Central-West Orana Renewable Energy Zone Transmission project

Amendment Report

March 2024

Table 3-6 Potential alternative option for location of switching station M1

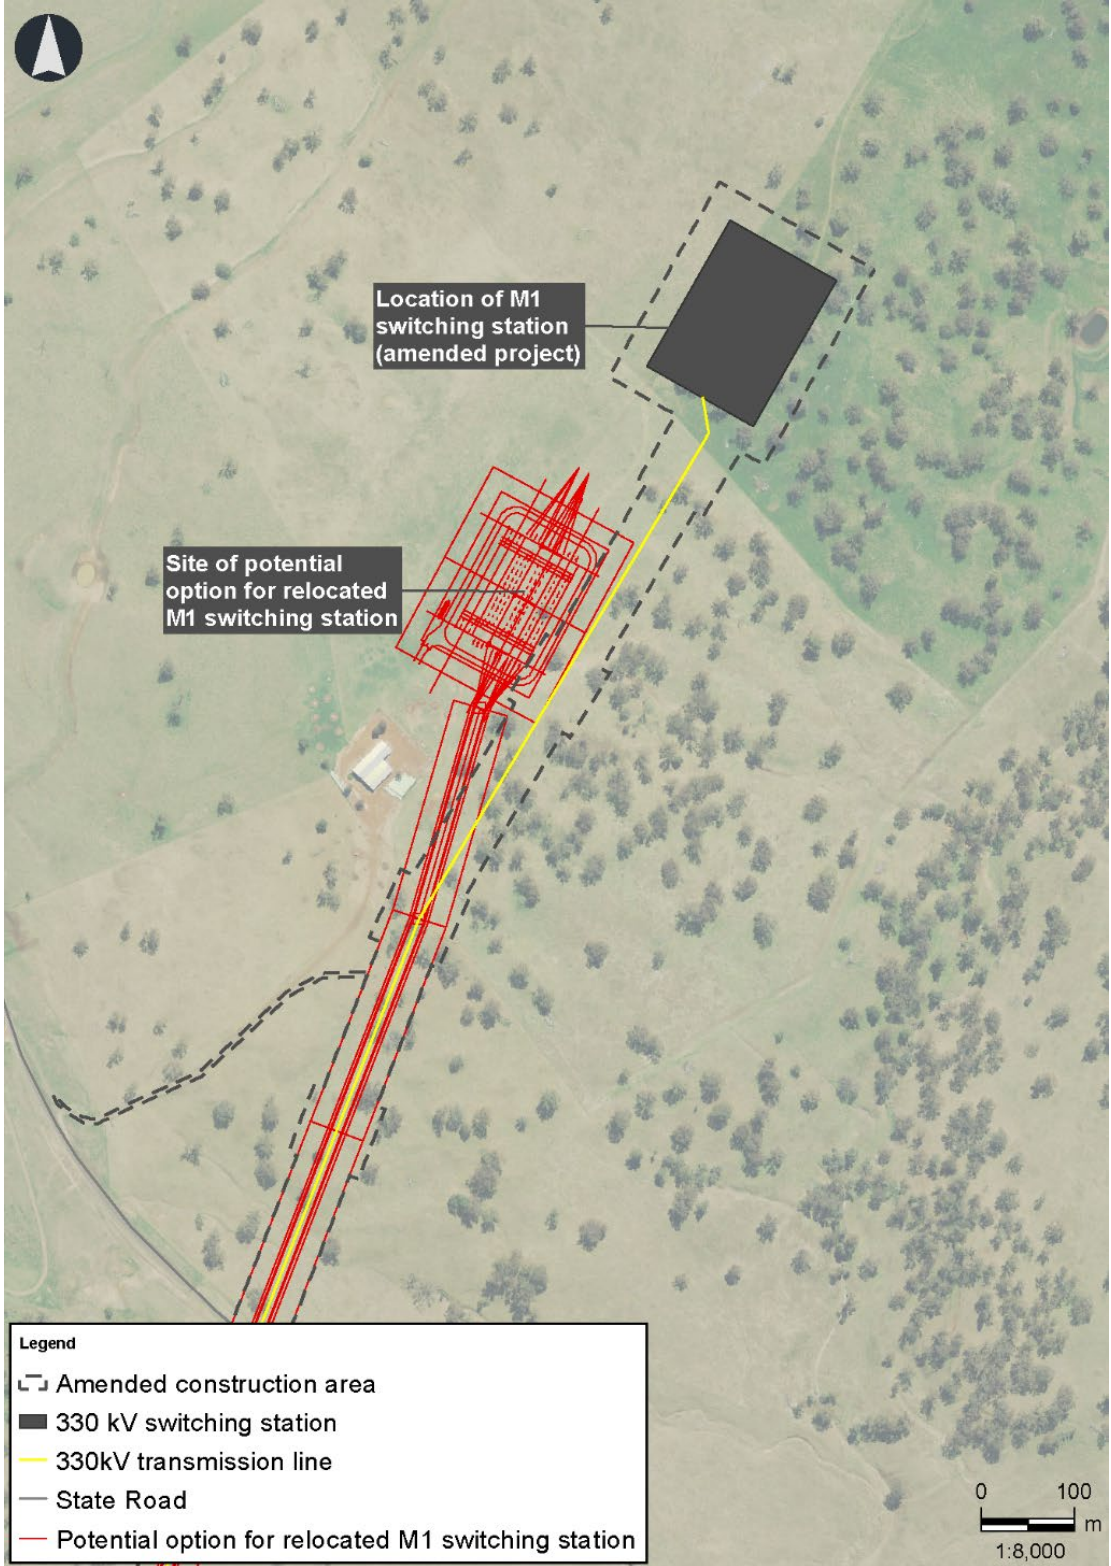
Potential relocation of switching station M1, and realignment of associated 330 kV transmission line
